**RE: Village at Mill Pond – Lilly Road Power and Sidewalk Deviation Request**

**RE: Mill Pond Sidewalk/Tree Impact Evaluation**

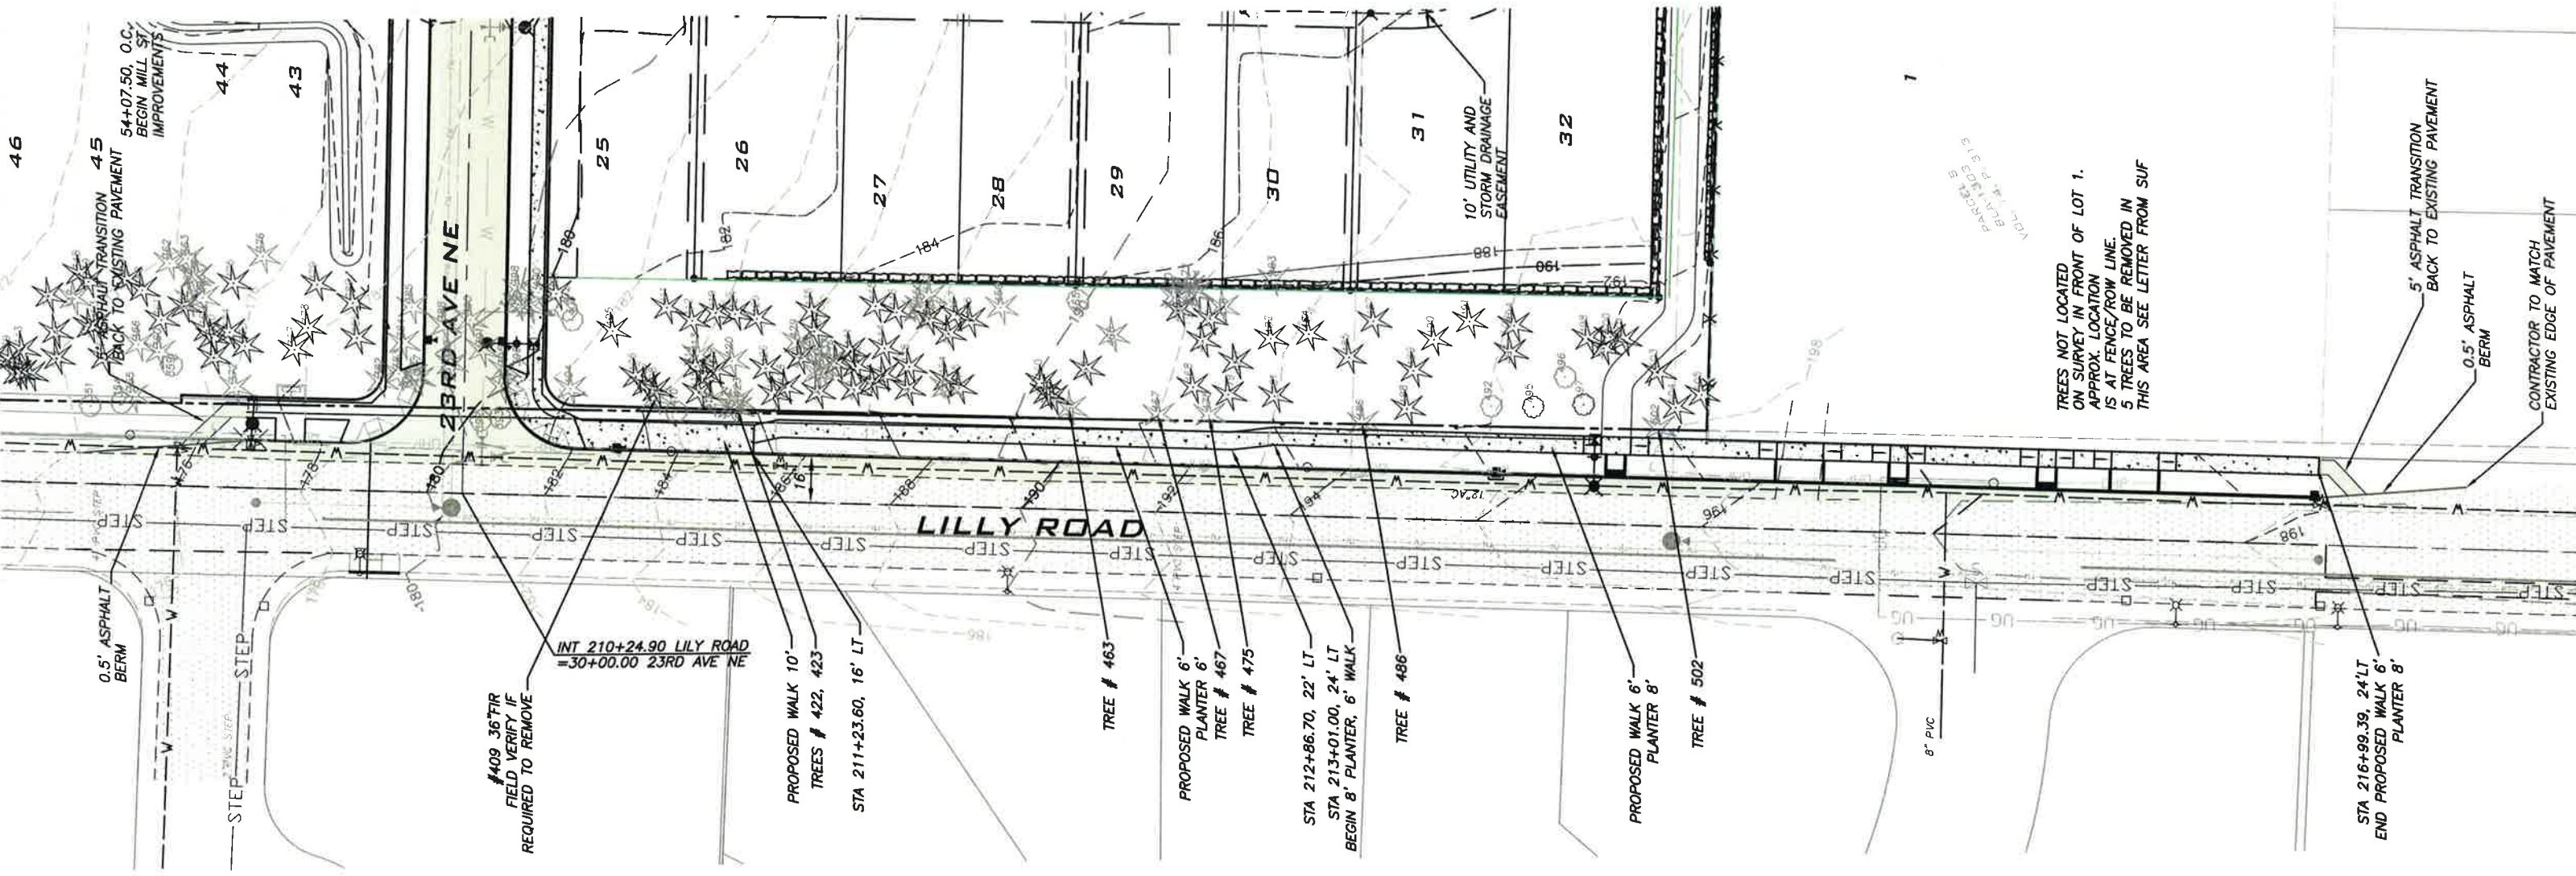
I have determined that the following trees will be impacted from the proposed sidewalk installation. The ID numbers were taken from the site map.

<b>Tree #</b>	<b>Species</b>	<b>Trunk Diameter (inches)</b>	<b>Comments</b>
409	Douglas Fir	36	The grading for the sidewalk may not impact this tree enough to require removal; the determination should be made on-site during the work and based on the amount of impacts to the critical roots
422	Douglas Fir	12	Direct conflict with the location of the sidewalk and grade cut and will need to be removed; removal of the stump should be done by excavator or stump grinder to limit the impact on adjacent trees
423	Douglas Fir	19	Direct conflict with the location of the sidewalk and grade cut and will need to be removed; removal of the stump should be done by excavator or stump grinder to limit the impact on adjacent trees
463	Douglas Fir	32	Direct conflict with the location of the sidewalk and grade cut and will need to be removed; removal of the stump should be done by excavator or stump grinder to limit the impact on adjacent trees

467	Douglas Fir	17	Direct conflict with the location of the sidewalk and will need to be removed; removal of the stump should be done by excavator or stump grinder to limit the impact on adjacent trees
475	Douglas Fir	15	Direct conflict with the location of the sidewalk and will need to be removed; stump can be pulled out without any impact to adjacent trees
486	Douglas Fir	22	Direct conflict with the location of the sidewalk and will need to be removed; removal of the stump should be done by excavator or stump grinder to limit the impact on adjacent trees

Tree #	Species	Trunk Diameter (inches)	Comments
502	Douglas Fir	18	Direct conflict with the location of the sidewalk and will need to be removed; removal of the stump should be done by excavator or stump grinder to limit the impact on adjacent trees

Along the developed parcel at the south end of the project, there are 5 Douglas fir proposed for removal. The trees are not shown on the current site plan. I have examined the adjacent trees within the parcel and they will remain wind firm if these 5 trees are removed.
